SUBJECT: ISSUANCE OF AMENDMENT (TAC NOS. 82020 AND M84842) - TSCR 208/220

THREE MILE ISLAND NUCLEAR STATION, UNIT NO. 1

Amendment No. 168  
License No. DPR-50

RELATED TO AMENDMENT NO. 168 TO FACILITY OPERATING LICENSE NO. DPR-50

Figure 3.5-2M

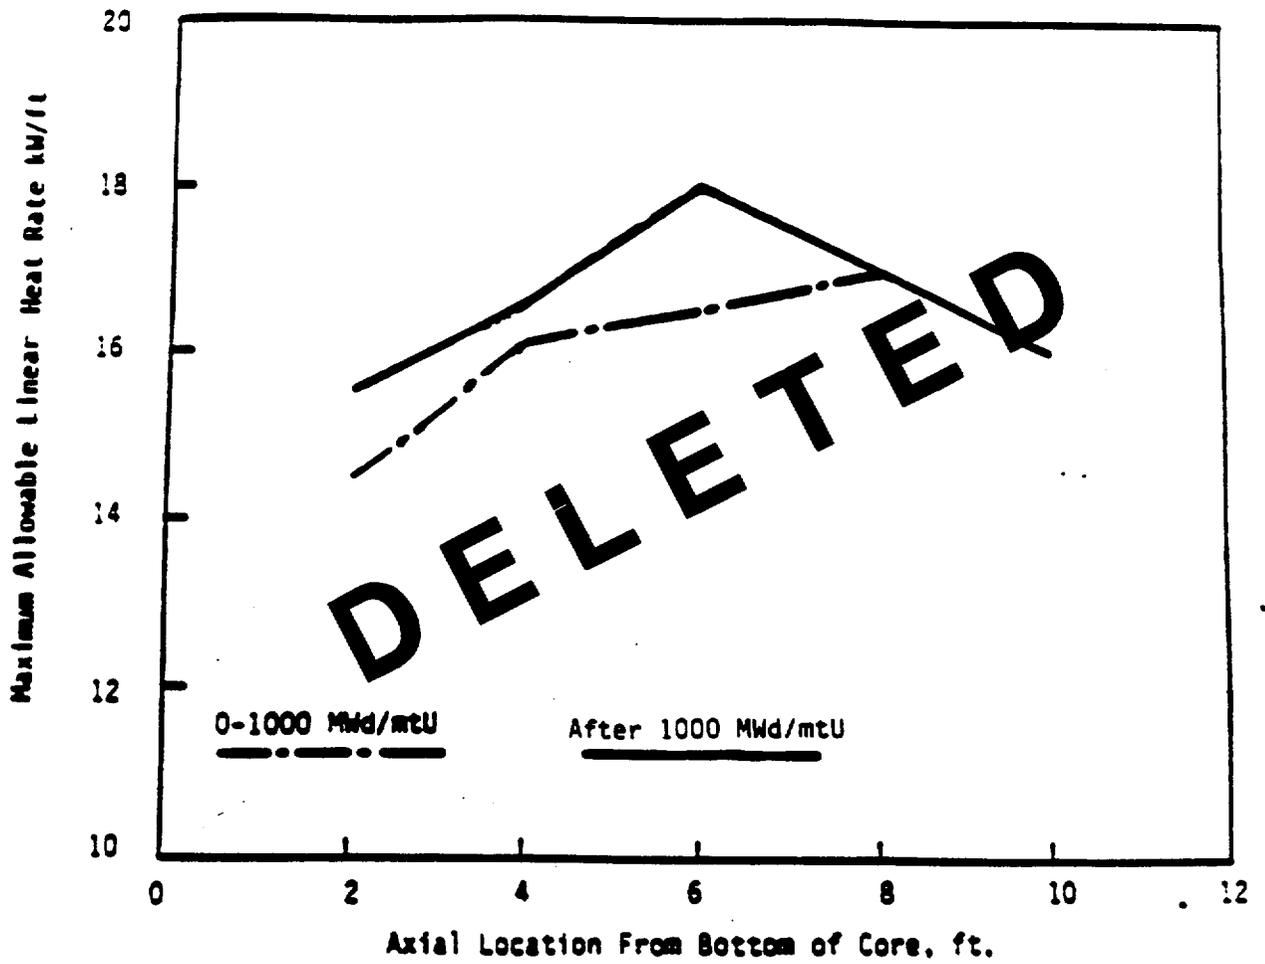
FIGURE DELETED AND INCORPORATED  
 INTO THE CORE OPERATING LIMITS REPORT.

By letter dated August 9, 1991, the licensee requested a change that would revise TMI-1 TS to reflect the B&W re-evaluation of the generic LOCA linear heat rate (LHR) allowable limits and to administratively update the Bases discussion associated with the minimum borated water storage volumes to ensure adequate shutdown margin. To assure preservation of 10 CFR 50.46 acceptance criteria over entire core life, the licensee developed new LOCA LHR limits using NRC approved B&W emergency core cooling system (ECCS) evaluation model and fuel performance computer codes (TS section 6.9.5.2 new references 9 through 12). From the analysis, LOCA LHR are required to be reduced at the 6 foot core evaluation from 16.5 to 16.1 Kw/ft at the beginning of core life (0 to 1000 MWD/MTU\*) and from 18.0 to 16.1 Kw/ft for above 1000 MWD/MTU. To assure that internal fuel rod pressure does not exceed reactor coolant system (RCS) pressure, the LHR limits are reduced at all core levels as a function of maximum rod average fuel burnup from 36,375 to 60,000 MWD/MTU. Re-evaluation of the peak clad temperatures at various fuel elevations using NRC approved analytical methods determined that peak centerline temperature (PCT) values meet the acceptance criteria using the new LHR limits. These re-evaluations for the revised generic allowable LOCA LHR for B&W 177A lowered-loop plants confirm the preservation of the acceptance criteria. These changes are reflected in the revised Figure 3.5-2M.

Application of B&W Topical Report BAW-1016P-A "TACO-3 Fuel Pin Thermal Analysis Computer Code" causes a new restriction on the end-of-life LOCA LHR limits. Accordingly, in order to maintain fuel rod internal pressure below RCS pressure for higher burnups, the allowable end-of-life LOCA LHR limits for all fuel assembly elevations are reduced based on the burnup of the limiting fuel rods. Figure 3.5-2M incorporates a diagonally decreasing limit as a function of maximum rod average burnup from 36,375 to 60,000 MWD/MTU.

By letter dated October 29, 1992, the licensee requested a change that would remove TMI-1 Figure 3.5-2M from the TS and incorporate it into the COLR. The licensee's proposed changes to the TS are in accordance with the guidance provided by Generic Letter 88-16, which allows the removal of cycle-specific parameter limits from TS. All changes in cycle-specific parameter limits are to be documented in the COLR before each reload cycle or remaining part of a reload cycle and submitted to the NRC prior to operation with the new parameter limits.
